# UNITED STATES PATENT AND TRADEMARK OFFICE

APPLICATION NO.	FILING DATE	FIRST NAMED INVENTOR	ATTORNEY DOCKET NO.	CONFIRMATION NO.
09/954,806	09/18/2001	Hiroyuki Akashi	09792909-5185	8207

## Office Action Summary

## DETAILED ACTION

Figure 4 shows the thickness of a positive electrode active material layer wherein P represents the electrode layer (section 0119).

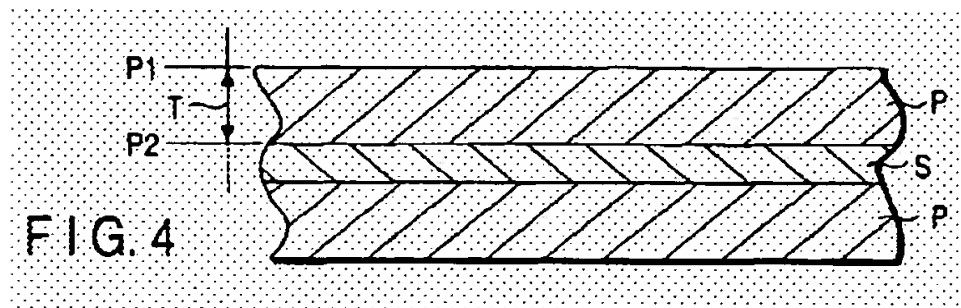
It is also disclosed that the positive electrode has a structure in which an electrode layer containing an active material is carried by one or both surfaces of the collector (section 0018). It is also disclosed that the negative electrode has a structure in which an electrode layer containing an active material is carried by one or both surfaces of the collector (section 0026)

The EP'960 reference teaches that the thickness of the positive electrode layer should be 10-100  $\mu\text{m}$ ; it follows that where positive electrode layers are formed on both surfaces of the collector, one positive electrode layer has a thickness of 10-100  $\mu\text{m}$ , naturally, the total thickness of the two positive electrode layers formed on both surfaces of the collector is 20-200  $\mu\text{m}$ . It is also disclosed that **the upper limit in the thickness is preferably 85  $\mu\text{m}$**  (section 0119/ 0158) (*←emphasis added*). Hence, the EP'960 reference envisions the claimed thickness, at least, from 80 to 100  $\mu\text{m}$  when one layer is formed, and at least, from 80 to 200  $\mu\text{m}$  when two layers are formed thereon.

The EP'960 reference teaches that the thickness of the negative electrode layer should be 10-100  $\mu\text{m}$ ; it follows that where negative electrode layers are formed on both surfaces of the collector, one negative electrode layer has a thickness of 10-100  $\mu\text{m}$ , naturally, the total thickness of the two negative electrode layers formed on both surfaces of the collector is 20-200  $\mu\text{m}$ . It is also disclosed that **the upper limit in the thickness is preferably 85  $\mu\text{m}$**  (section 0125/ 0161) (*←emphasis added*). Hence, the EP'960 reference envisions the claimed thickness, at least, from 80 to 100  $\mu\text{m}$  when one layer is formed, and at least, from 80 to 200  $\mu\text{m}$  when two layers are formed thereon.

Thus, given that the EP'960 reference has clearly disclosed that the upper limit in the thickness for both the positive electrode and the negative electrode is preferably 85  $\mu\text{m}$ , as well, in general, electrode layers having a thickness of 10-100  $\mu\text{m}$ , it is fairly reasonable to contend that the EP'960 reference envisions at first the claimed thickness, and consequently, the claimed ratio A/B. (*Emphasis added*→) For instance, if the upper limit in the thickness for the positive electrode is chosen to be 90  $\mu\text{m}$ , then the thickness of the negative electrode can be thus chosen to be about 82  $\mu\text{m}$  which still satisfies a preferred electrode thickness; or in the other hand, if the positive electrode thickness is chosen to be 100  $\mu\text{m}$ , then the thickness of the negative electrode can be thus chosen to be about 91 which is still within the generally disclosed range. In this regard, it is noted that this examiner's position is taken in light of the specific electrode thickness exemplified in TABLE 6 (See portions of TABLE 6 below) which shows positive electrodes and negative electrodes having different thickness dimension. Therefore, the EP'960 reference does not strictly require that the thickness dimension of both electrodes (i.e. the positive electrode and the negative electrode) be identical or the same. In other others, the EP'960 reference at once
